PROPOSAL, CONTRACT, BOND AND SPECIFICATIONS

E Main Street and South Hancock Street Assessment District - 2025

CONTRACT NO. 8784

1. REVISED SHEETS: D-1, D-2, D-6, D-7, INT-2, INT-3, INT-7, P-1, P-2, P-4, P-6, U-1 - U-7, U-12, W-1, W-2, W-5 - W-7, E-1 - E-9, PM-8, X-15, AND X-16.

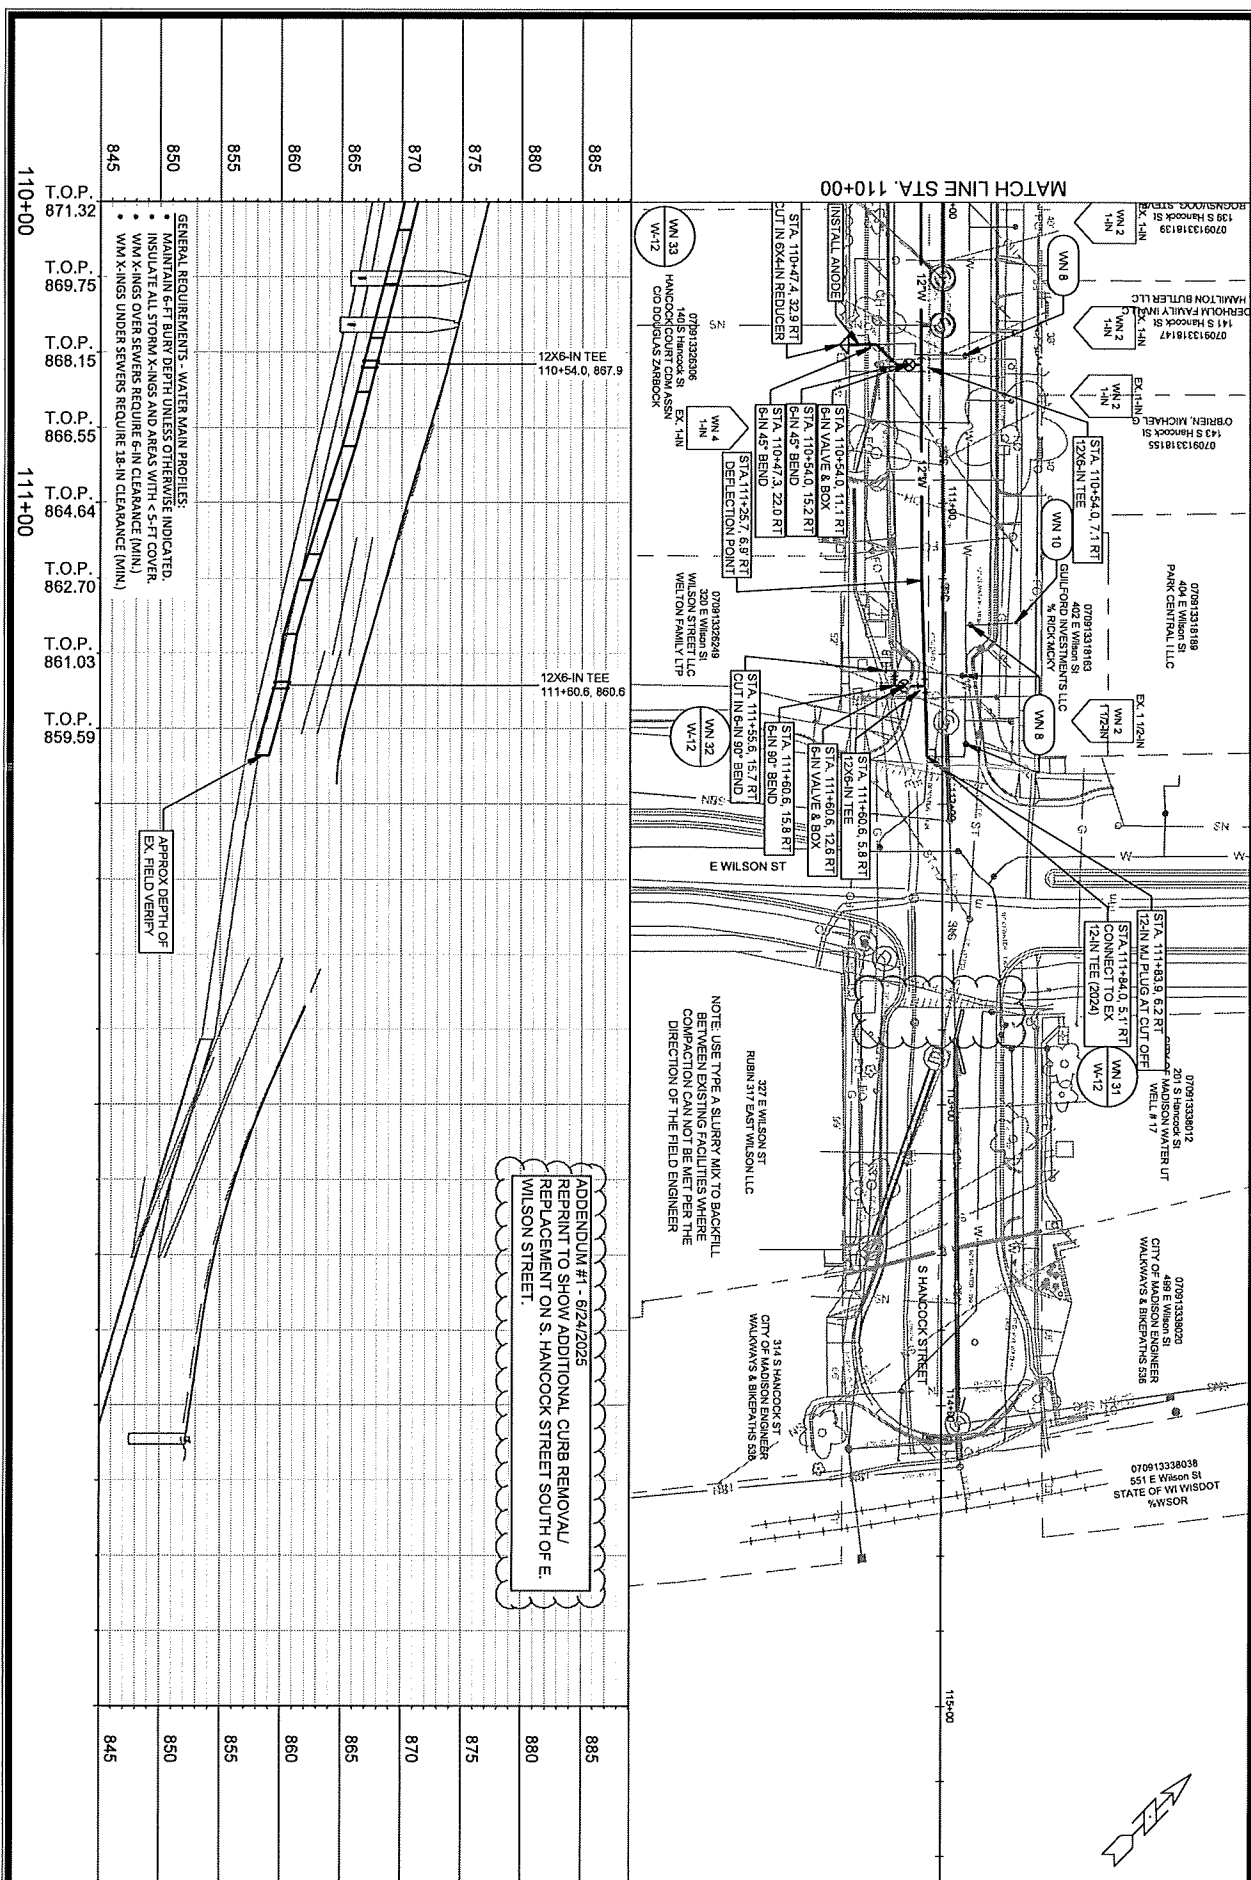
ADDENDUM #1 - 6/24/2025
 REPRINT TO SHOW ADDITIONAL CURB REMOVAL/
 REPLACEMENT ON S. HANCOCK STREET SOUTH OF E.
 WILSON STREET.

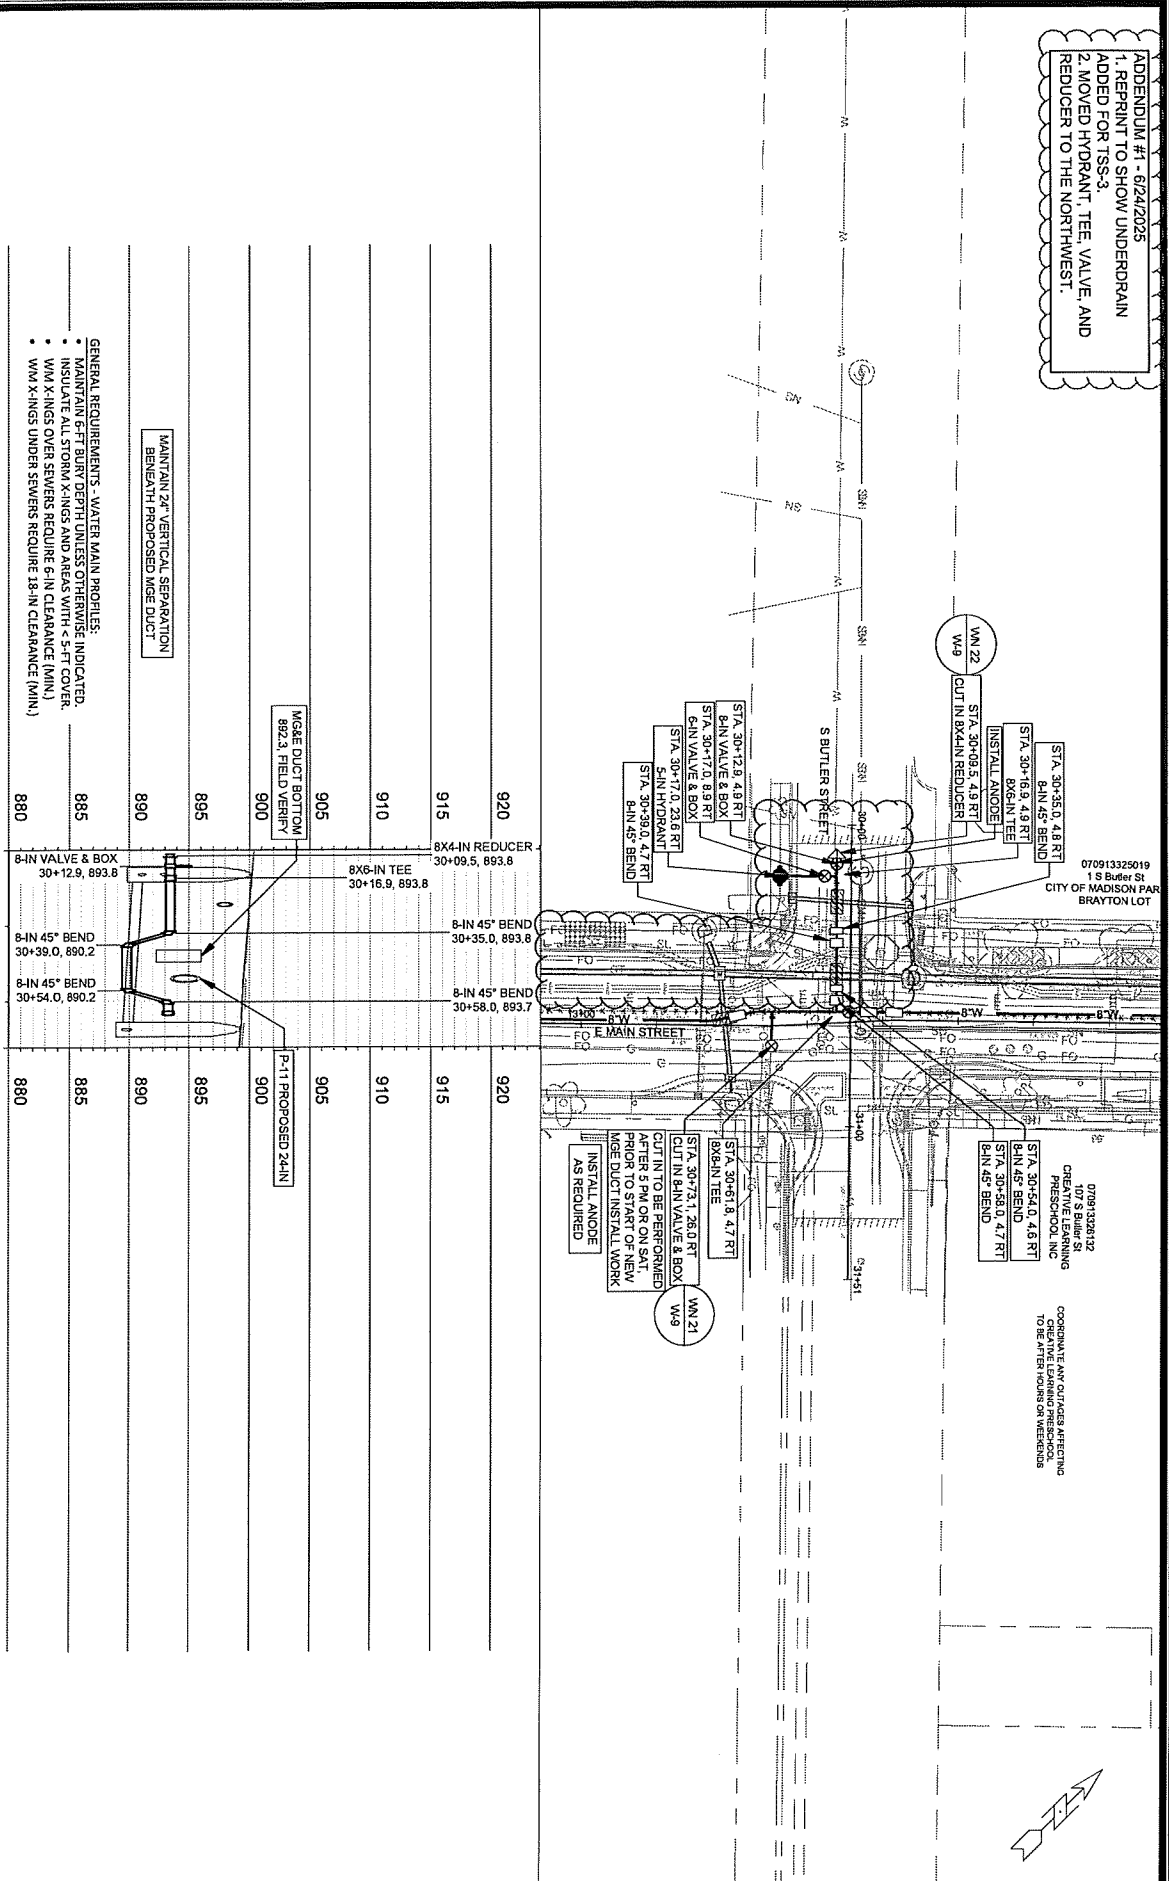
ADDENDUM #1 - 6/24/2025
 1. REPRINT TO SHOW UNDERDRAIN
 ADDED FOR TSS-3.
 2. MOVED HYDRANT, TEE, VALVE, AND
 REDUCER TO THE NORTHWEST.

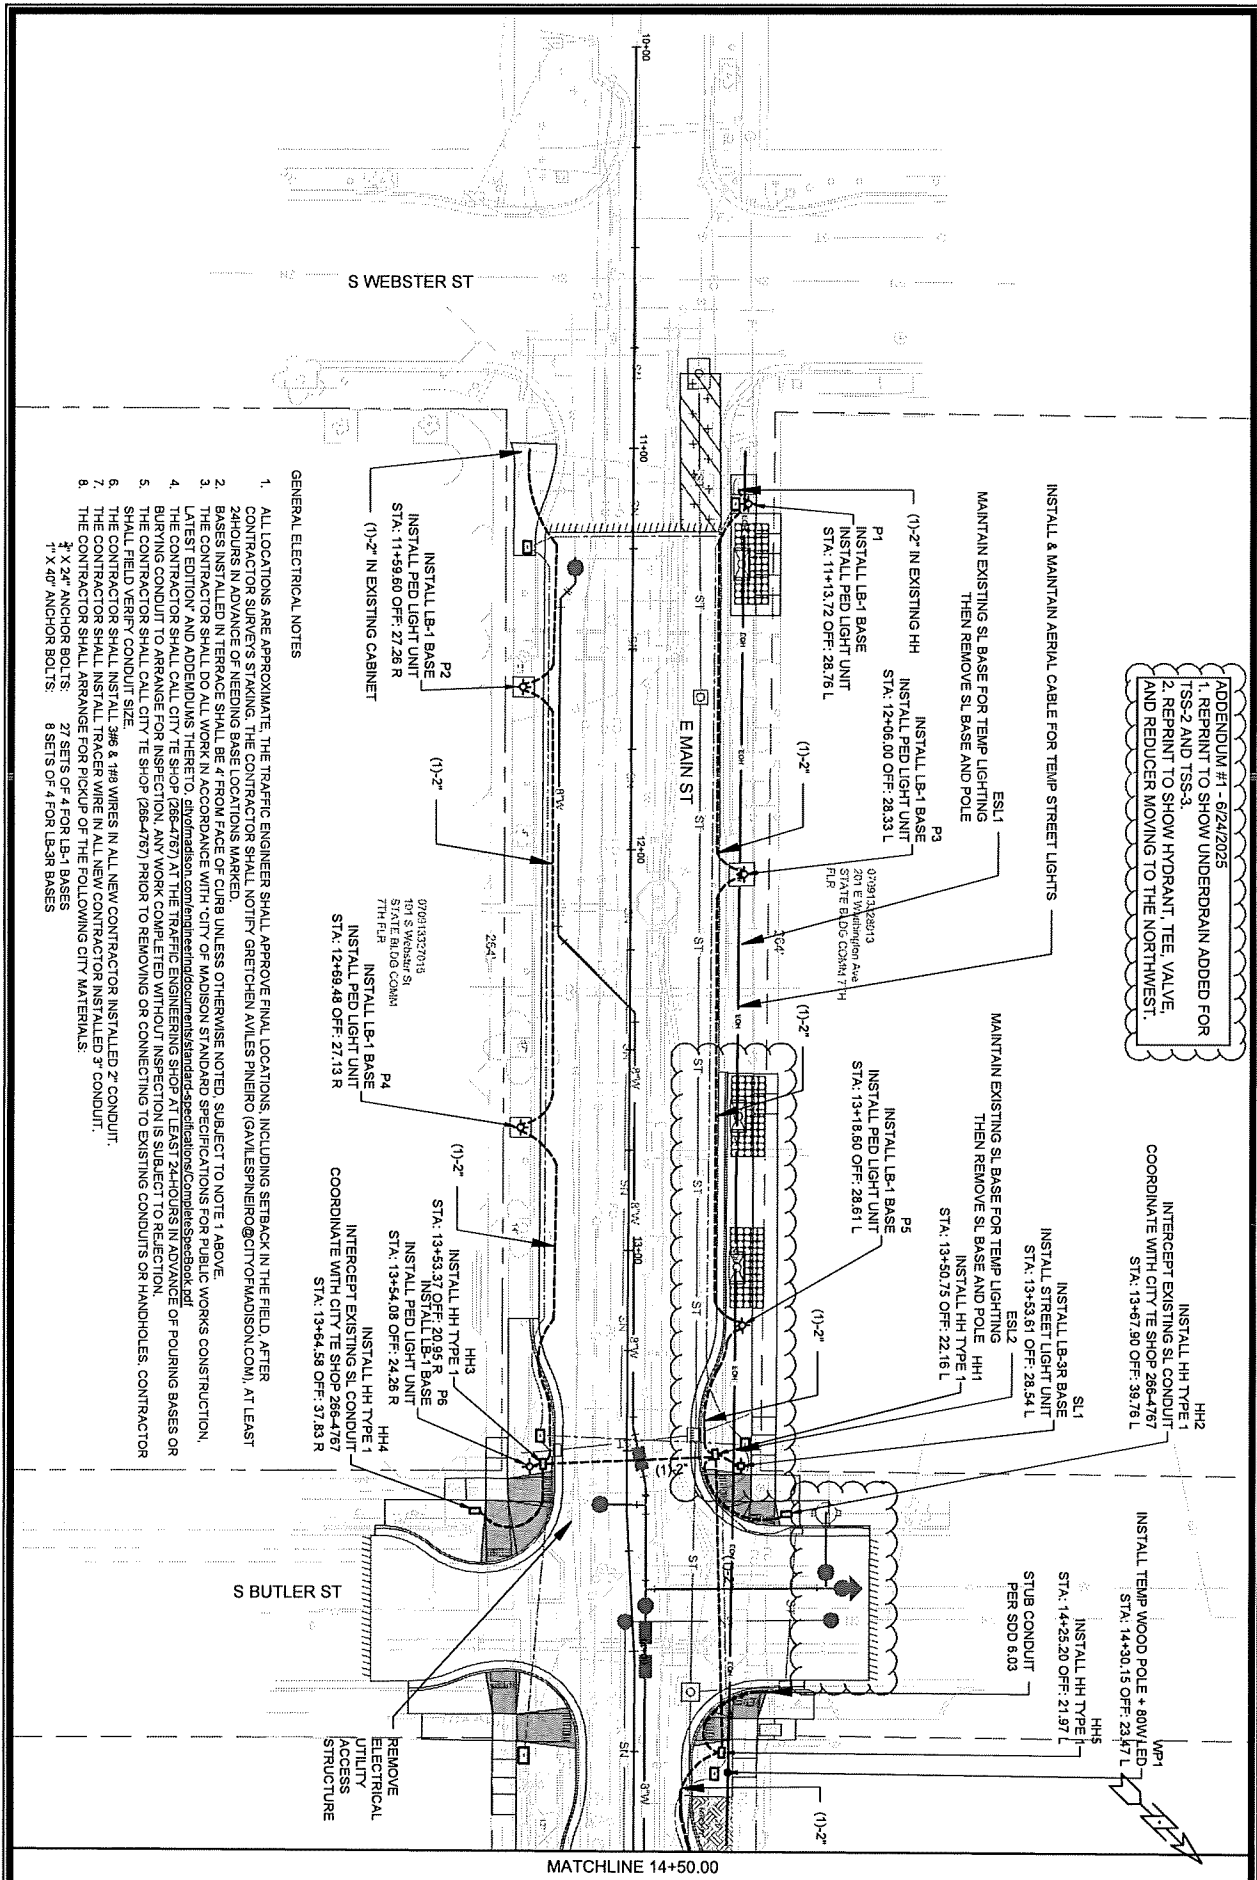
ADDENDUM #1 - 6/24/2025
 1. REPRINT TO SHOW UNDERDRAIN ADDED FOR TSS-2 AND TSS-3.
 2. REPRINT TO SHOW HYDRANT TEE, VALVE AND REDUCER MOVING TO THE NORTHWEST.

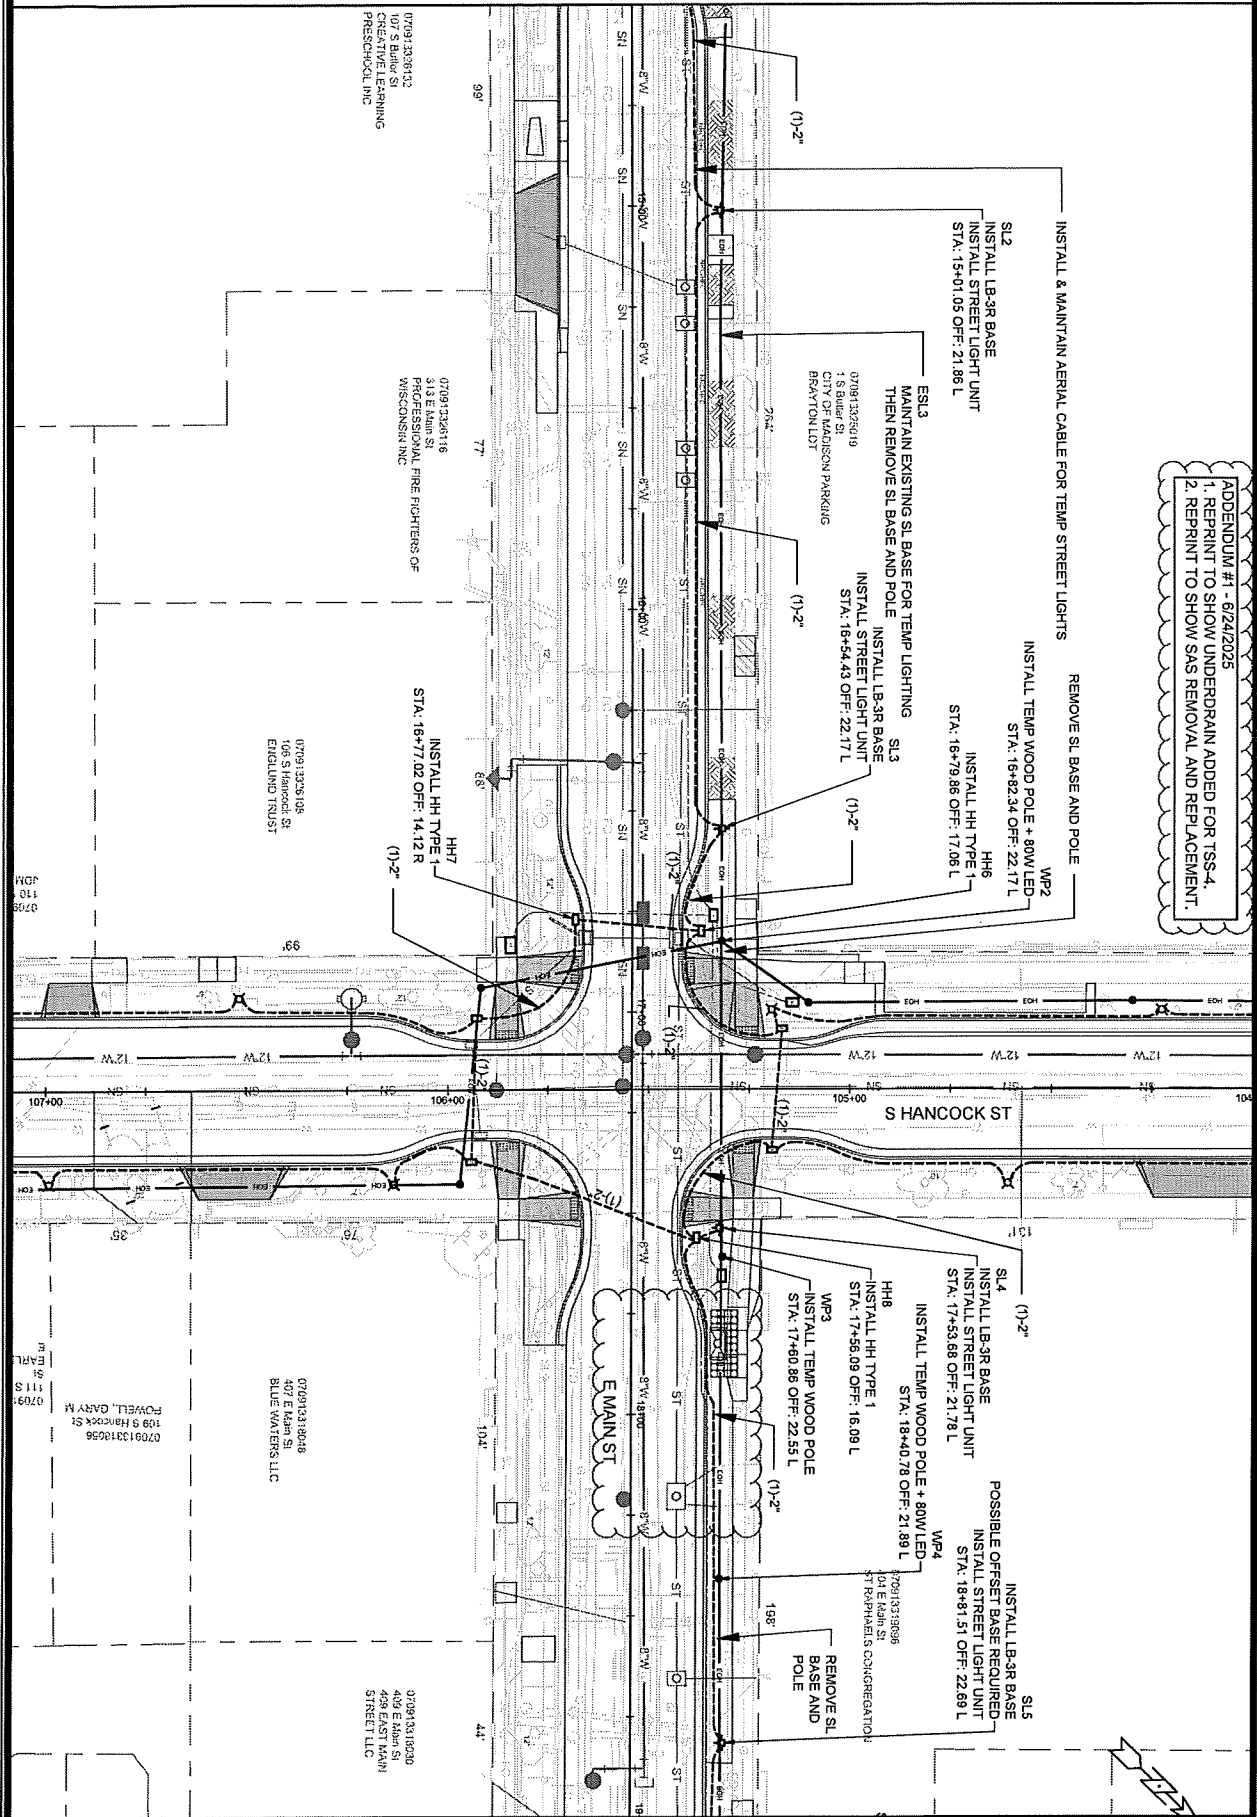
ADDENDUM #1 - 6/24/2025
1. REPRINT TO SHOW UNDERDRAIN ADDED FOR TSS-4.
2. REPRINT TO SHOW SAS REMOVAL AND REPLACEMENT.
